This Service Information bulletin supersedes SI 11 04 12 **dated May 2012**.

Voluntary Emissions Recall Campaign 11E-A03: Check and/or Replace Emissions Monitoring Components

E70 and E90 with the M57Y engine produced from January 2010 to March 2011

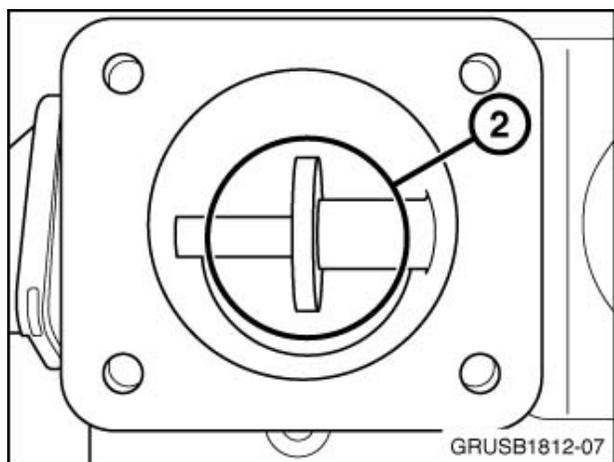
Remove the charge air pipe at the throttle (ignition off). Using a flashlight, look through the throttle (1) and inspect the EGR valve.

The updated EGR valve (P/N 11 71 8 517 217 or P/N 11 71 8 512 526) has the valve and seat directly in the airstream of the throttle (1). If this valve is installed, no further action is needed. Reinstall the charge air pipe.

The original EGR valve has a diffuser in the airstream flow from the throttle (2). The valve for EGR actuation is seated further into the EGR airstream. Replace this valve with P/N 11 71 8 512 526 (Repair Instruction 11 71 501).

The DDE will also need to be programmed as part of the Recall. If the HP EGR valve is replaced, the DDE will need to be programmed after the new EGR valve is installed. This new software package contains the necessary software to adapt the DDE to the new EGR valve strategy.
